**Concept plan for residential development at
the Crowle Home / Achieve Australia site,
74-76 Belmore Street, Ryde**

MP10_0110 MOD3

Secretary's
Environmental Assessment Report
Section 75W of the
Environmental Planning and Assessment Act 1979

May 2014

Figure 16: The location of the two proposed full height projections to the north eastern elevation of Block A (Base source: proponent's Response to Submissions)

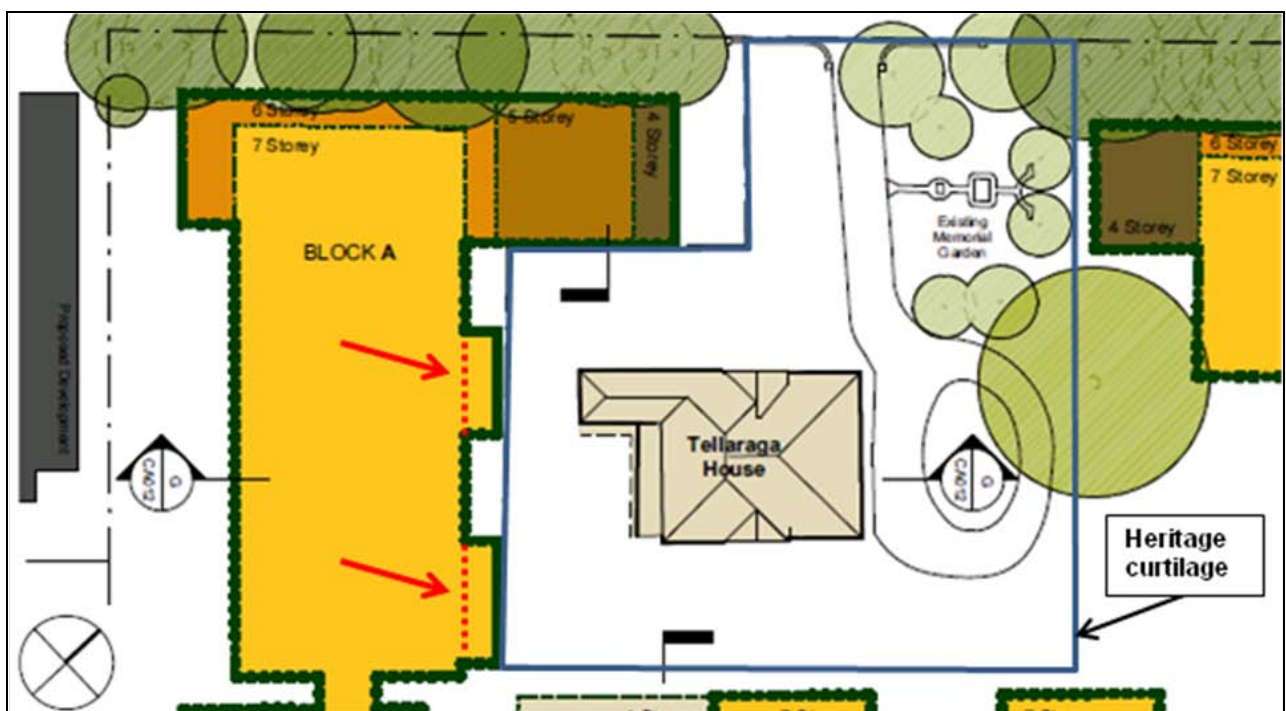
Two full height projections (3 metres deep and 11.5 metres wide) are proposed to Block A on its north eastern elevation, which the proponent states will allow for the appropriate articulation of the façade (refer to **Figure 16**). The Council has raised concerns that the protrusions encroach on Tellaraga House, increase the building depth beyond what the RFDC recommends and result in overlooking / privacy issues.

The department notes that the projections would, in part, infill the 3 metre space between Block A and the heritage curtilage. However, neither projection would encroach on the approved heritage curtilage of Tellaraga House. The department considers that the proposed projections would not significantly alter the setting of Tellaraga House in the context of the height and scale of the approved building envelopes that frame the heritage item. Furthermore, the department notes that the proposal includes the removal of Block F building envelope (as shown in **Figures 5 and 6**) and considers that this omission would improve the setting of the heritage item. Overall the

The Block A building envelopes, as approved, has a depth of 21 metres. The department notes that the RFDC recommends a building depth of 18 metres and the proposed projections would increase the building depth of Building A, in part, to 24 metres.

department considers that the proposal would have a beneficial impact on the setting of Tellaraga House and is therefore acceptable in this regard.

The department considers that issues relating to overlooking/privacy can be appropriately addressed as part of the future detailed development application for the site.

Figure 17: The location of the through site pedestrian link as required by commitment no.34 (Base source: original EA MP10_0110)

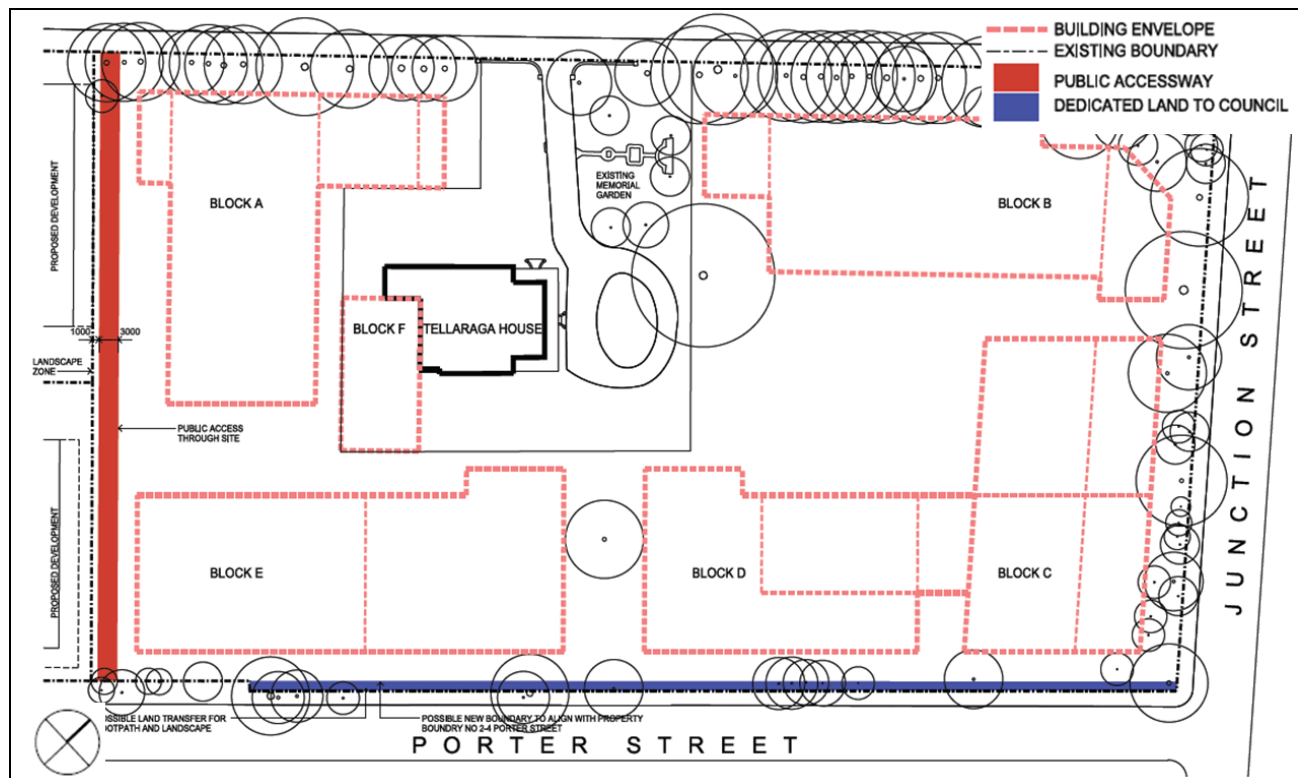
Statement of Commitment no.34 committed the proponent to providing a through site pedestrian link along the south western boundary shared with 2-4 Porter Street (refer to **Figure 17**). The Commitments also states that should a through site link be provided on 2-4 Porter Street before commencement of work on the site then the through site link would not be required on the Crowle Home site.

The proponent is consequently requesting that Statement of Commitment no.34 be deleted. Council has supported the deletion of Statement of Commitment no.34. However, Council has

raised concerns that the legal right-of-way over the through site link does not extend to the boundary with the site and this jeopardises the access into the link to the subject site.

The department notes Council's concern, however, considers that the intent of the concept plan to ensure an east/west pedestrian link between Porter and Belmore Streets has been met by the through site link being provided at the neighbouring site. The department does not dispute that there may be added advantage in providing additional access to the subject site however notes that the matter of the legal right of way is best addressed at the future development application stage. Notwithstanding this view, the department considers that even if an accessible pathway linking Blocks A and E to the through site link cannot be provided, there are numerous other opportunities along Porter, Belmore and Junction Streets for residents and visitors to enter the site and proposed buildings. It is therefore recommended that Statement of Commitment no.34 be deleted as proposed.
